SPIRE-RAL-PRJ-00624
10th April 2001 version updated in brown
24th August, 2001

GROUNDING and SCREENING PHILOSOPHY

SPIRE GROUNDING SCHEME PROPOSAL

The schematic diagram of the PSPICE simulation is shown here:

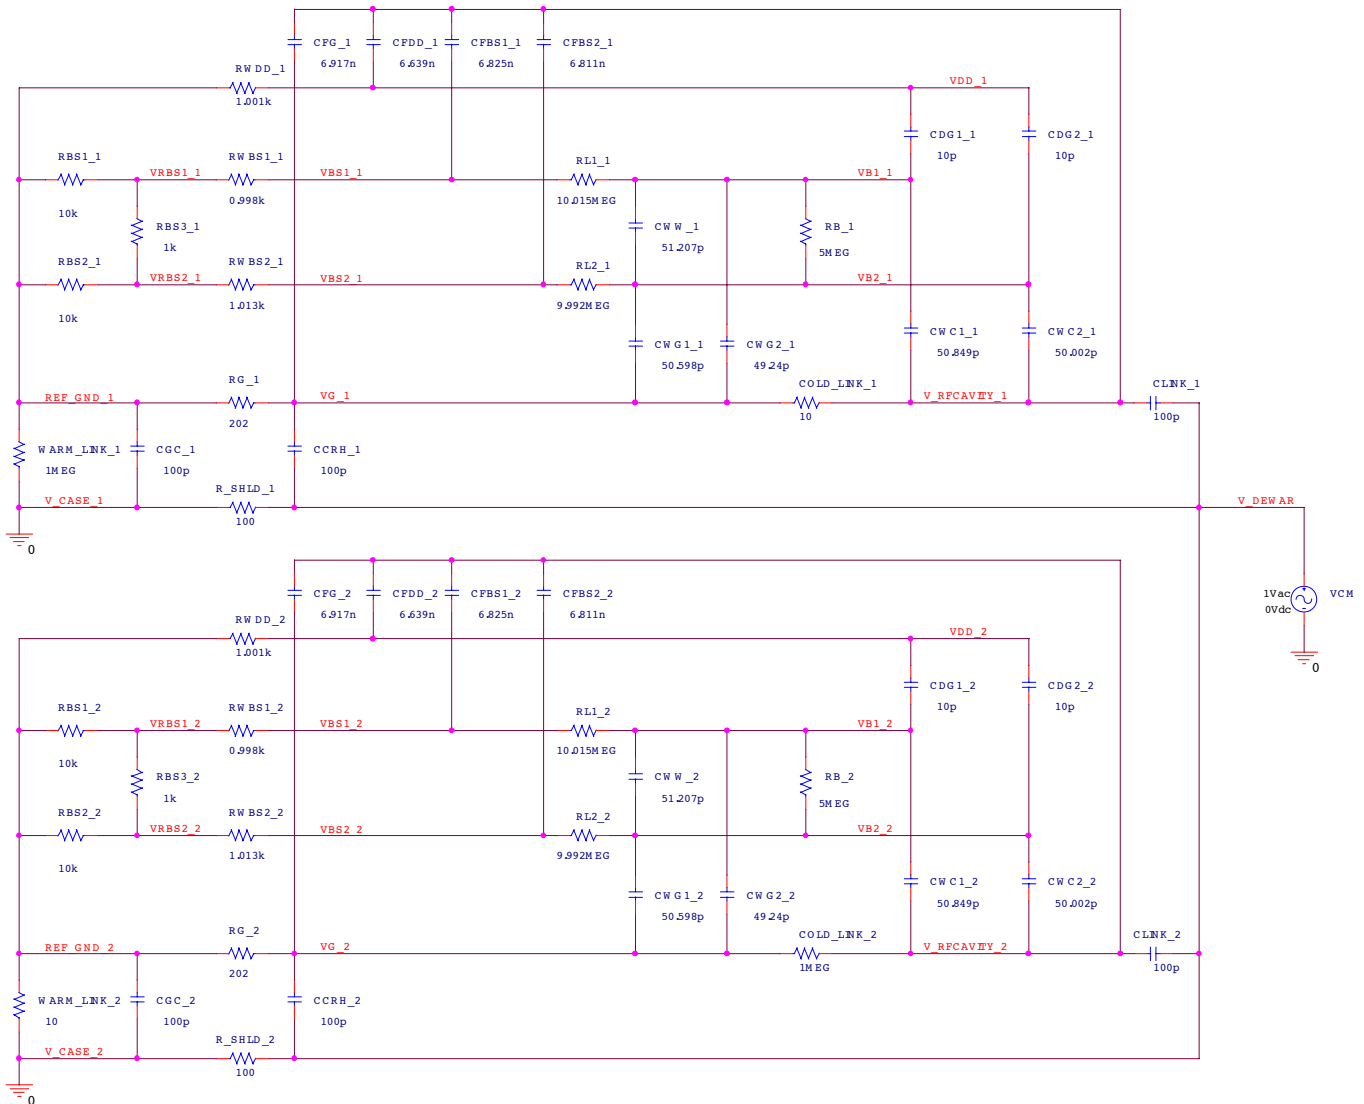
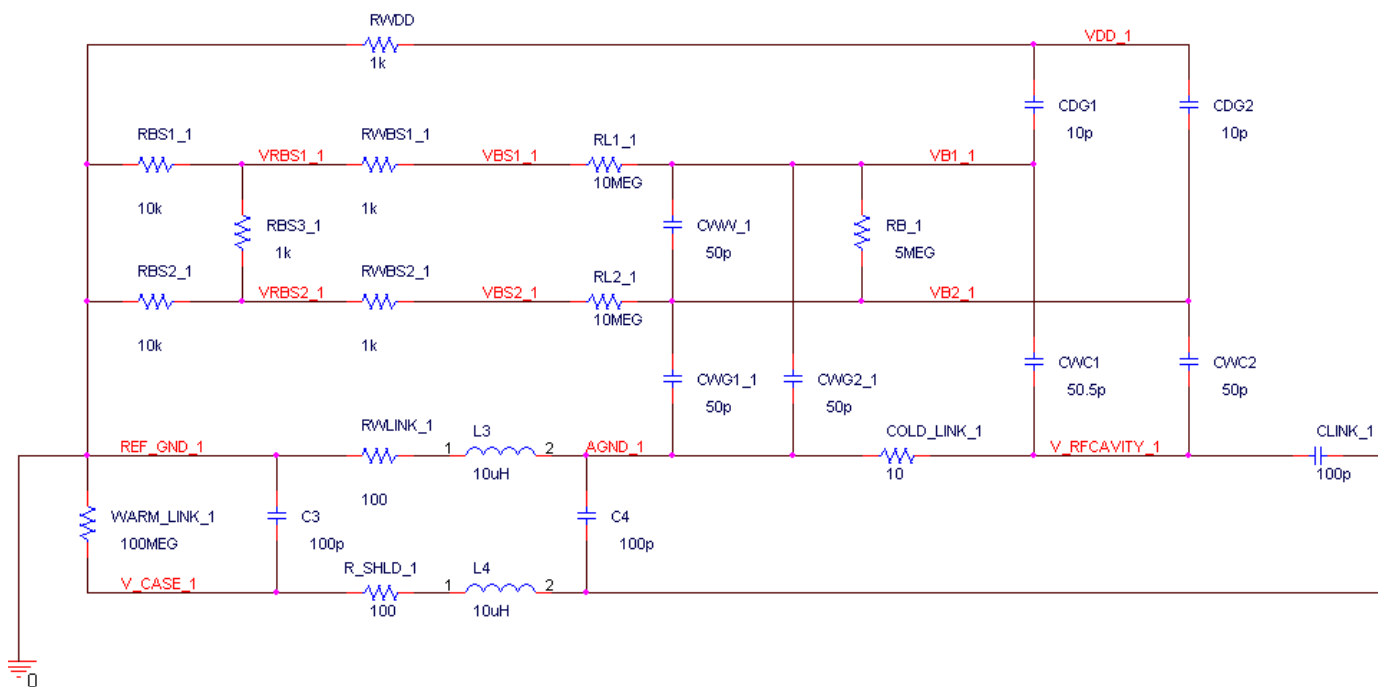
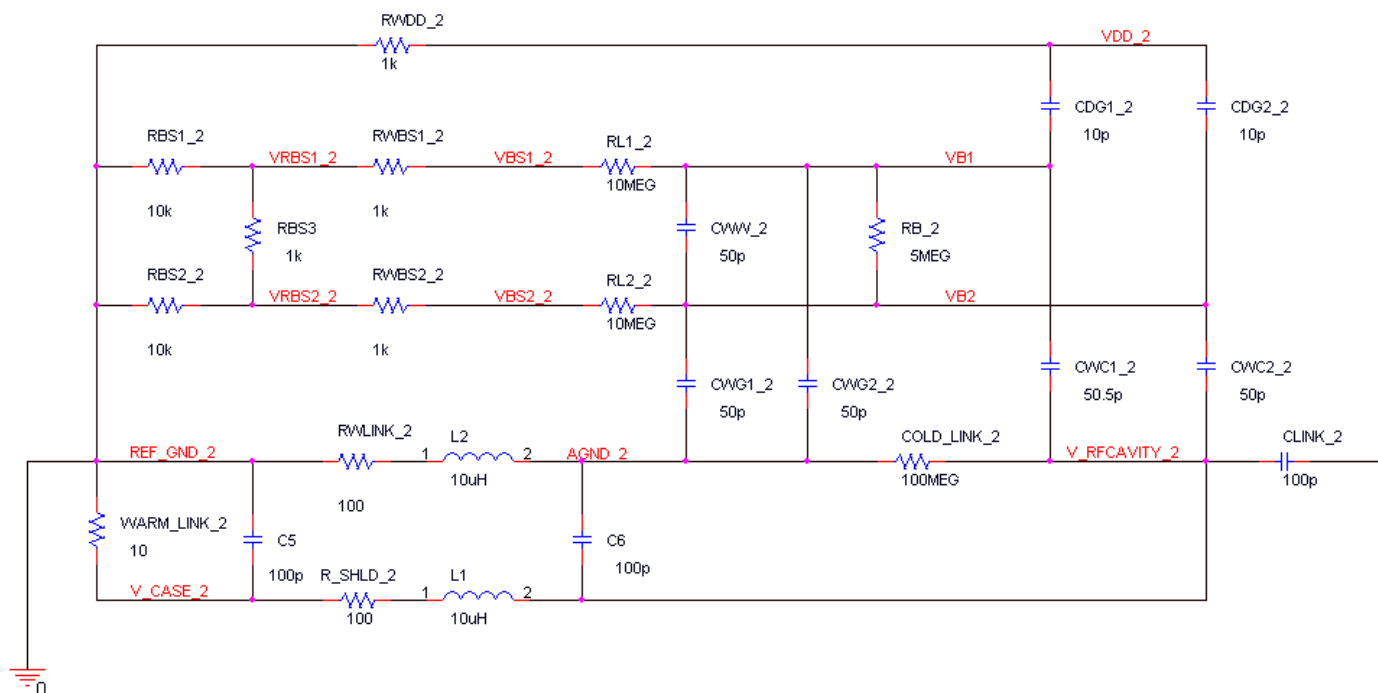
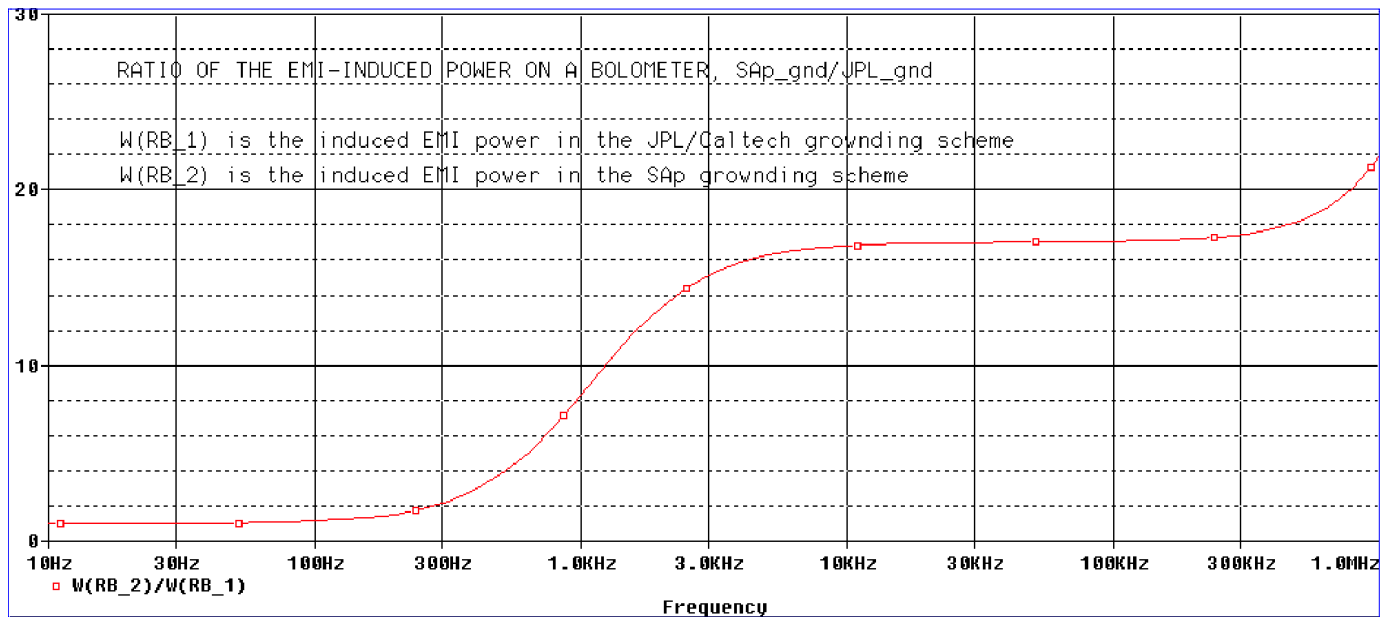
The upper block represents the JPL/Caltech grounding strategy with a high impedance link between the bolometer reference ground and the chassis, and a low impedance link between the bolometer reference wiring and the Faraday cage.

The lower block represents the SAp grounding strategy with a low impedance link between the bolometer reference ground and the chassis, then a low impedance link between the chassis and the Faraday cage.

To estimate the relative merits for each of the grounding schemes, a ratio of the power dissipated on the respective bolometer due to the common EMI source is taken.

According to this naive simulation, the SAp grounding scheme will perform SIGNIFICANTLY worse than the JPL/Caltech one. At very low EMI source frequencies both grounding schemes perform in similar fashion, at medium frequency range characteristic for the SMPS ripples at operational frequency of 20-100 KHz, the SAp grounding is worse, and at the high frequency end, associated with the SMPS switching noises, the SAp scheme performs even worse.
